# **CAMPBELLO STREET EXTENSION**

## **SITE PLAN**

### **STAFF REPORT**

Re: Town of Hudson Planning Board Review  
Campbello Street Subdivision Plan  
Tax Map 165, Lot 49; Acct. #1350-133  
Reference No. 20030249.2320

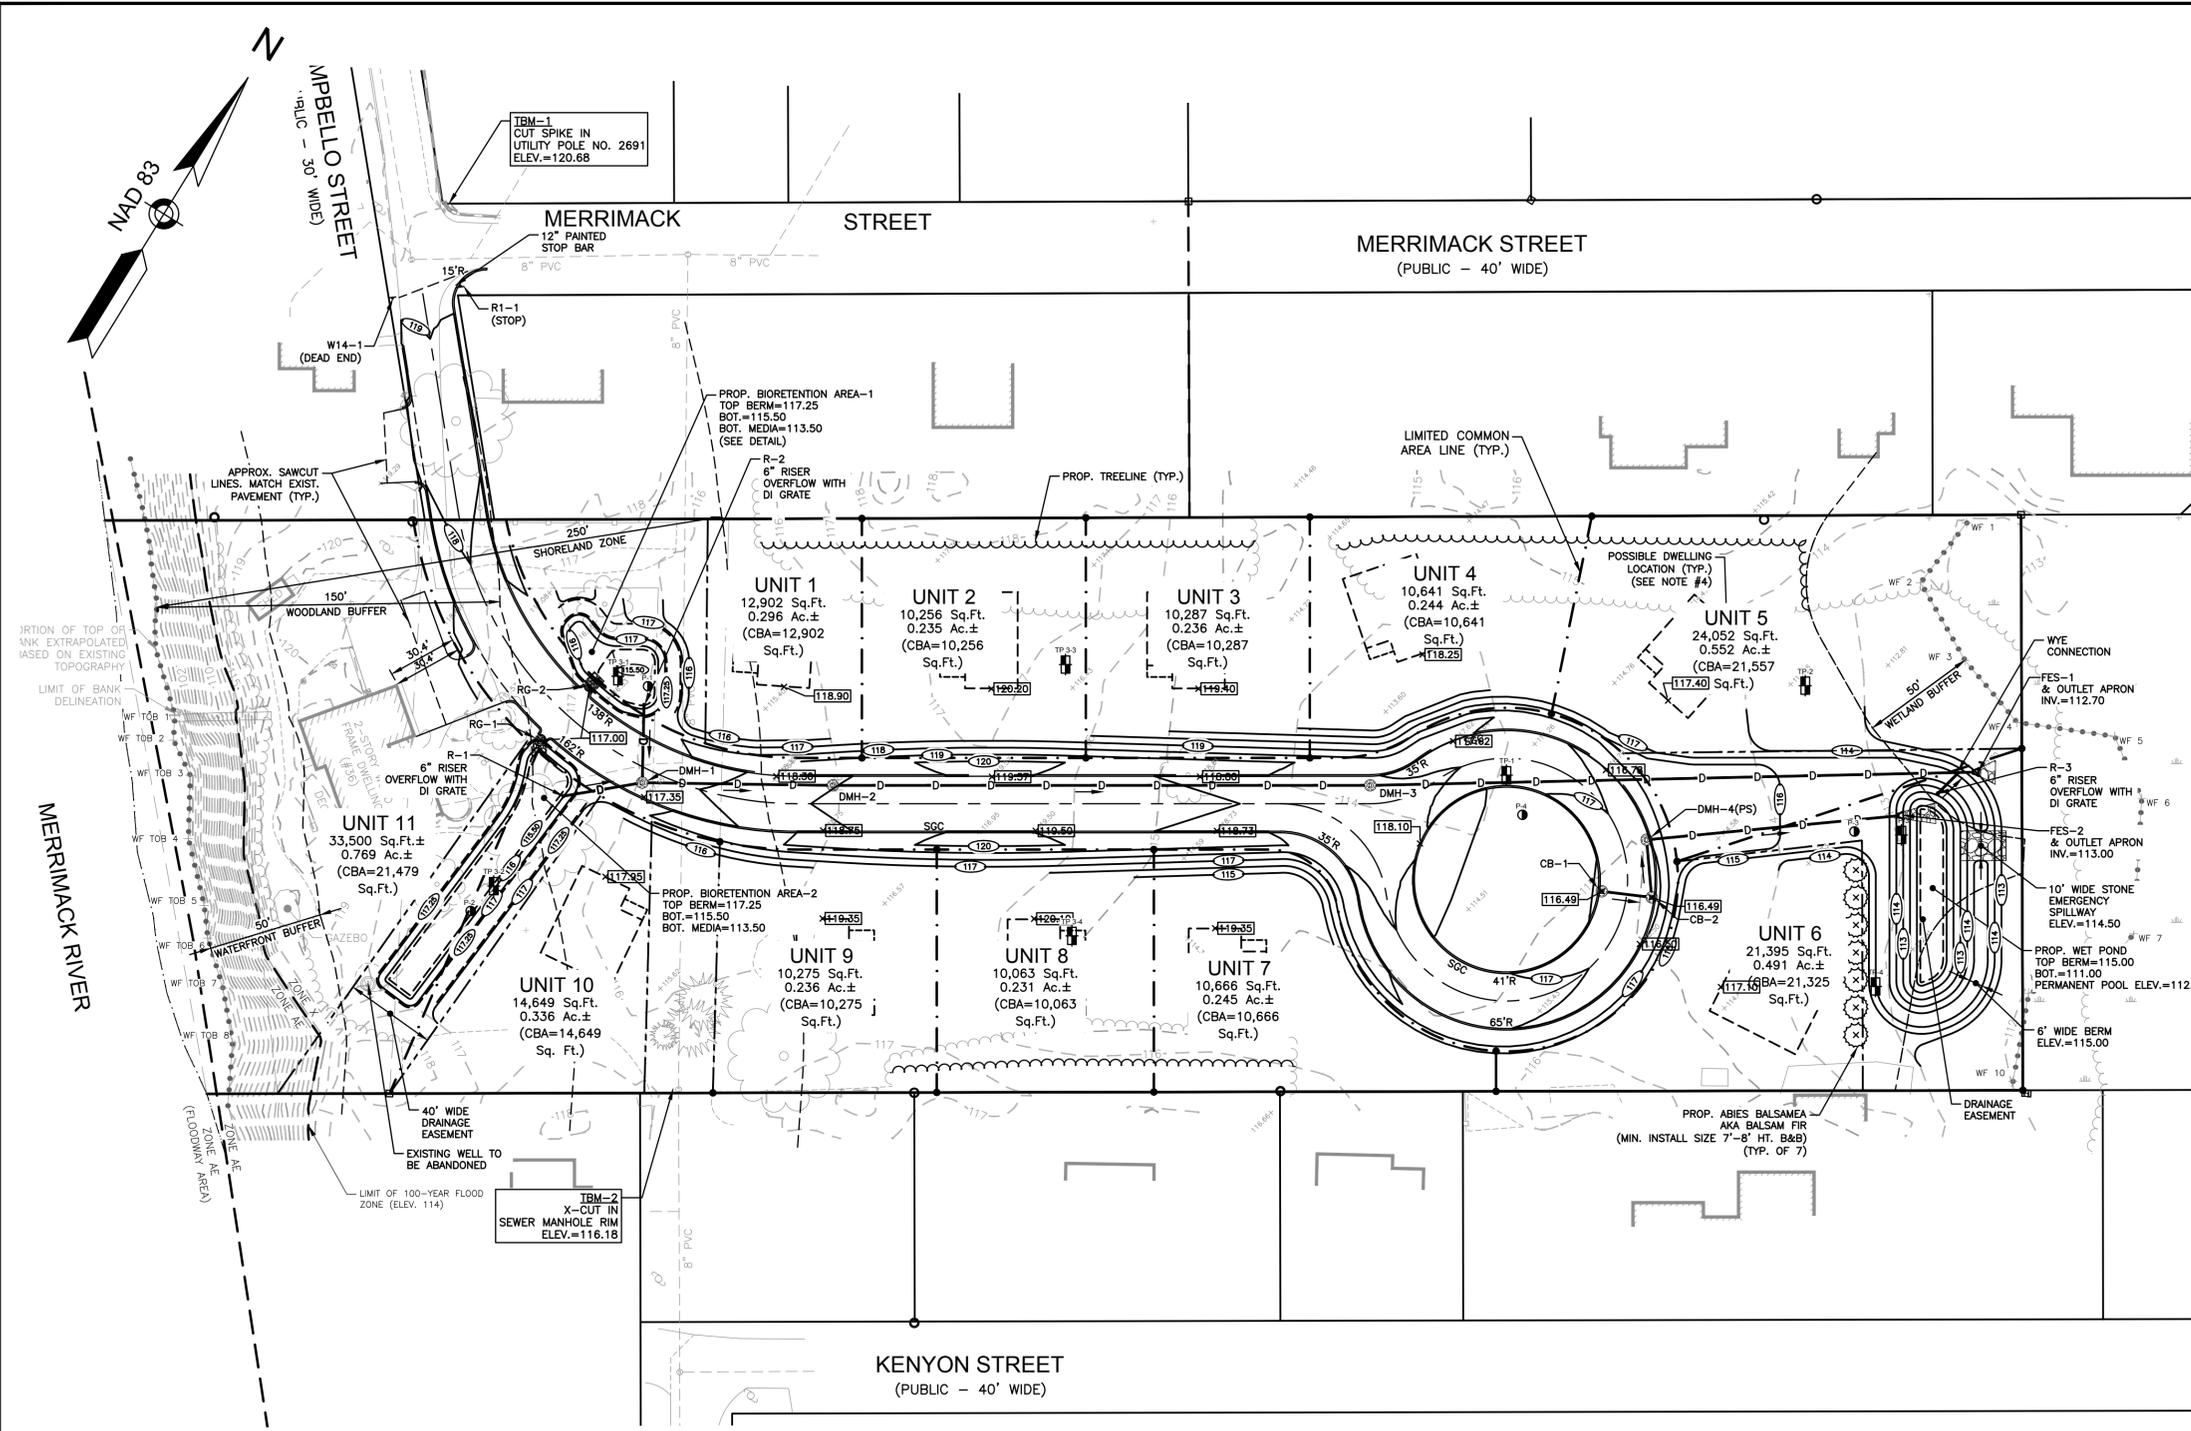
1. During Construction and restoration erosion control barriers shall be installed and maintained to the satisfaction of the Town Engineer.
2. It is recommended that the outflow from Outlet Apron noted as FES-1 shown on sheet 7 of 16 of the plan set be redirected into Infiltration Basin-3.

SCALE: 1"=40'  
 PROJECT NO. NEX-2300191  
 7 OF 16

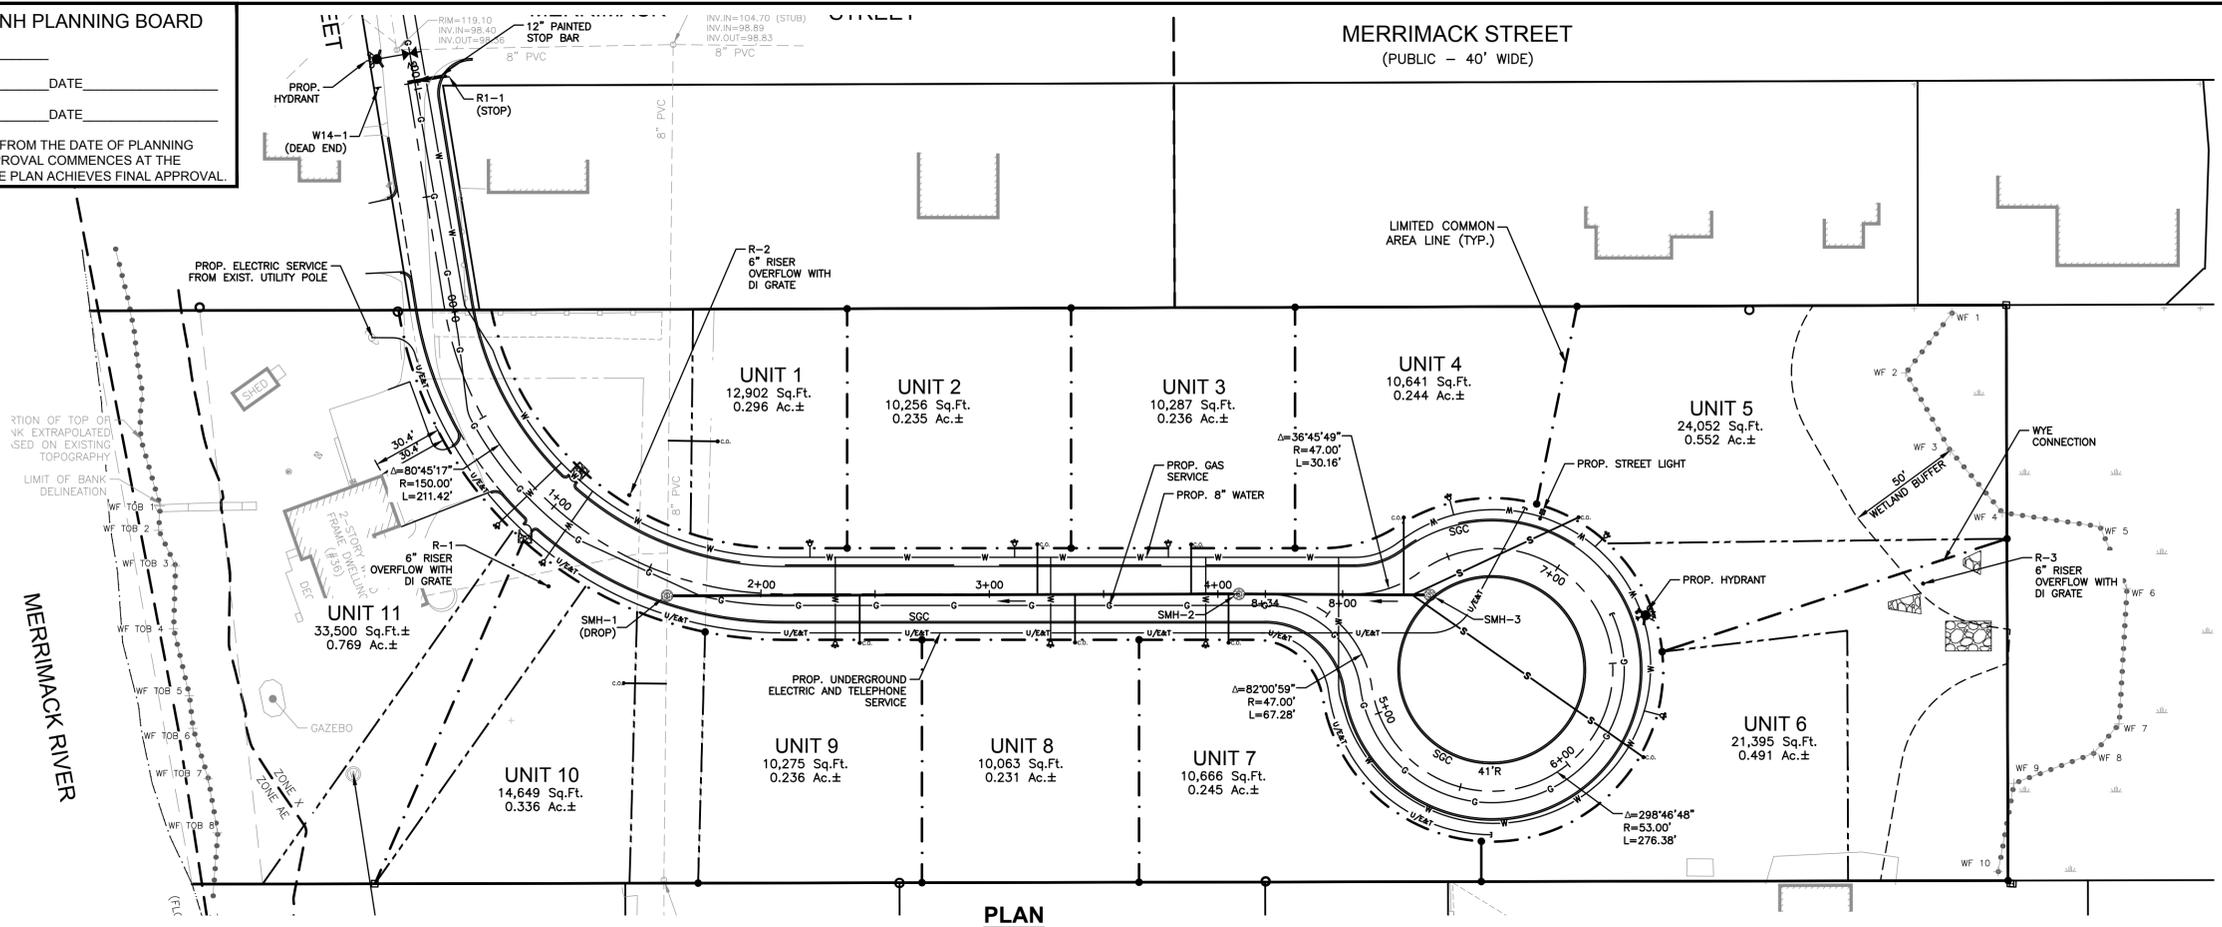
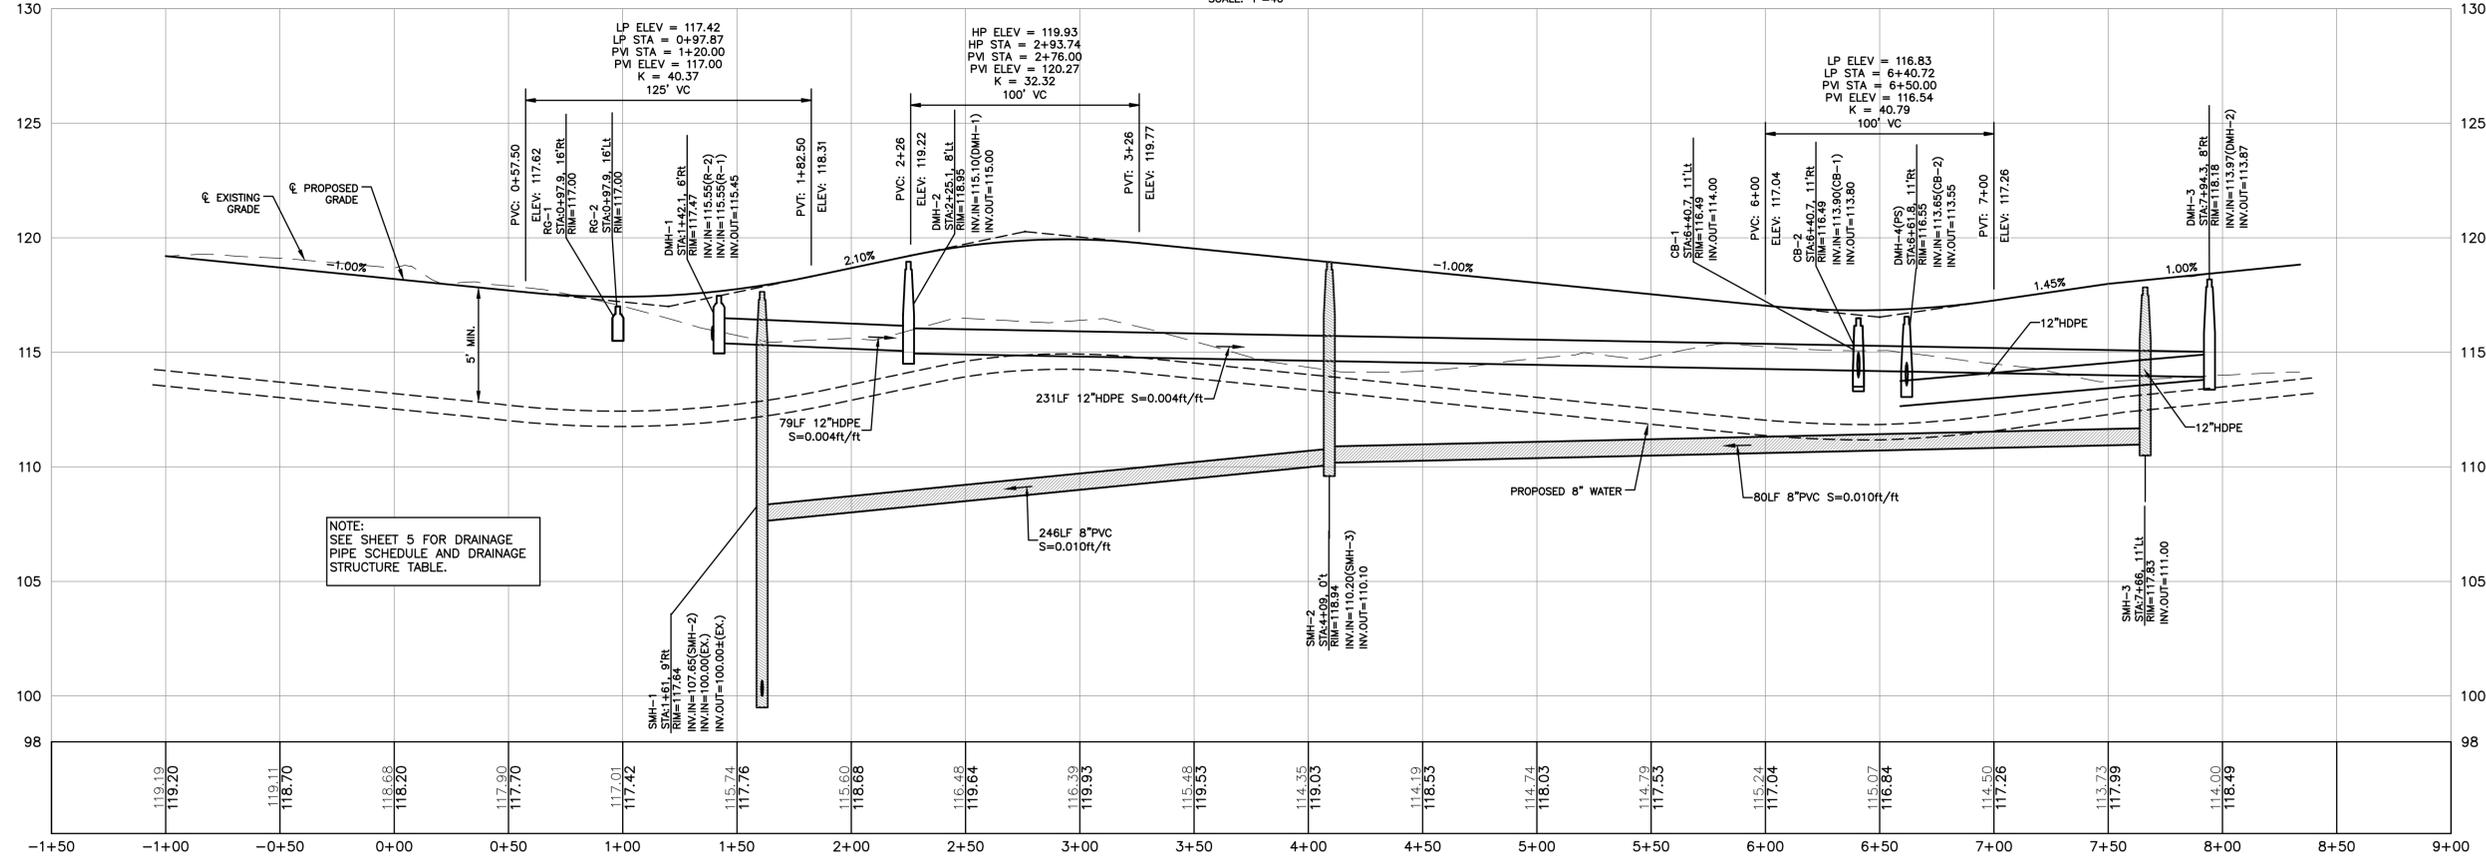
- b. HR 289-18.B.(5). The applicant should add the dead-end sign location to the plan set. Sign details should also be provided.
- c. The applicant should show a stop bar location and detail on the plan set along with a stop sign detail.

- d. HR 289-18.C.(1). The applicant should show horizontal curve information on the plan set.
- e. HR 289-18.R.(b). & 289-28.G. The applicant has requested a waiver from providing sidewalks.

**A Dead End sign has been added where Campbello Street meets Merrimack Street. Details of all proposed signs have been added to Sheet 7.**

**A stop bar has been added to the plans on Sheet 7 and a detail provided on Sheet 16.**

**Horizontal curve information has been added on Sheet 7 as requested.**
